General Motors Upfitter Integration

Fuel Fill Tube Repositioning Subject:

Models Affected: GMT610 Cutaway w/33 Gallon Fuel Tank

UI Bulletin #141b

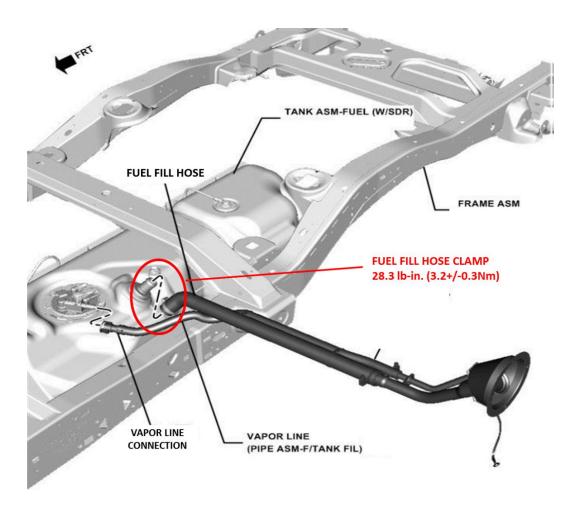
The fuel fill tube used on the 2017 model year GMT610 Cutaway models with side mounted 33gallon fuel tank was changed. During the vehicle build the fuel fill tube is installed to facilitate filling the fuel tank at the assembly plant. To prepare the vehicle for shipping purposes, the fuel fill tube was secured to the frame with tie wraps. With this process the rubber hose used to attach the fill tube to the fuel tank would twist, collapse and not return to its original shape after release from the frame, causing a complaint of hard to fill the fuel tank.

It is recommended that the upfitter determine the vintage of the vehicle by build date or VIN and examine the orientation of the fuel fill hose. If it is determined the vehicle was built on or after the breakpoint, the fuel filler hose must be repositioned to the vertical position.

To reposition the fuel fill tube, the clamp closest to the fuel tank must be loosened and the fuel fill tube and hose assembly rotated to the vertical position, as installed in a completed vehicle. The lower hose clamp must be retightened to 28.3 lb.-in. (3.2 +/-0.3Nm).
